**Technical Service Bulletin (TSB)**  
**Air Conditioning Not Blowing Cold or is Inoperative**

<b>REFERENCE:</b>	<b>TSB:</b> 24-002-24 <b>GROUP:</b> 24 - Heating and Air Conditioning	<b>Date:</b>	May 14, 2024	<b>REVISION:</b>	–
<b>VEHICLES AFFECTED:</b>	<p><b>2023 - 2025 (B1) Jeep Renegade</b> <b>2023 - 2025 (M1) Jeep Compass</b> <b>2023 - 2025 (H1) Jeep Commander</b></p> <p><b>This bulletin applies to:</b></p> <ul style="list-style-type: none"> <li>• <b>B1</b> vehicles built on and after September 01, 2023 (MDH 0901XX) and on and before March 13, 2024 (MDH 0313XX).</li> <li>• <b>M1</b> vehicles built on and after September 01, 2023 (MDH 0901XX) and on and before March 05, 2024 (MDH 0305XX).</li> <li>• <b>H1</b> vehicles built on and after September 01, 2023 (MDH 0901XX) and on and before March 07, 2024 (MDH 0307XX).</li> </ul> <p><b>Equipped with either the:</b></p> <ul style="list-style-type: none"> <li>• 1.3L I4 Turbo MAIR DI Engine W/ESS (Sales Code EYF) <b>or</b></li> <li>• 1.3L I4 Turbo MAIR DI Engine (Sales Code EYH) <b>or</b></li> <li>• 1.3L I4 Turbo MAIR DI Engine W/ESS E100 (Sales Code EYJ).</li> </ul>	<b>MARKET APPLICABILITY:</b>

**Fig. 1**

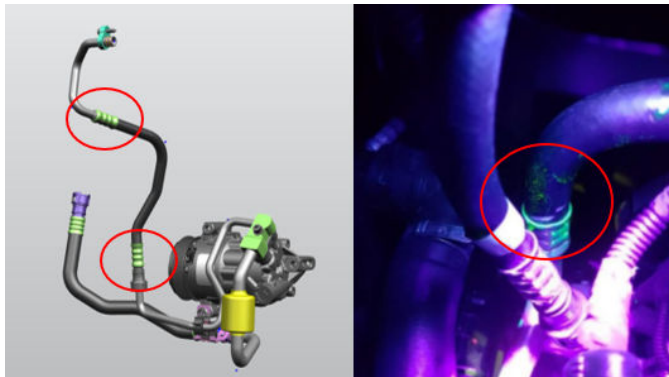
Inspect for leaks all around the circumference of the A/C lines **Fig. 1**.

Areas Of Potential Leaks

7. Replace the A/C suction and liquid double line. Refer to the detailed service procedures available in DealerCONNECT/Service Library under: Service Info> 24 - Heating and Air Conditioning / Plumbing / Assembly, A/C Suction and Liquid Line / Removal and Installation.

8. Tighten the fasteners on the connectors to the proper torque:
  - Refrigerant Lines to A/C Compressor:
    - 9 N·m (80 In. Lbs.) (6mm Bolts).
    - 20 N·m (80 In. Lbs.) (8mm Bolts).
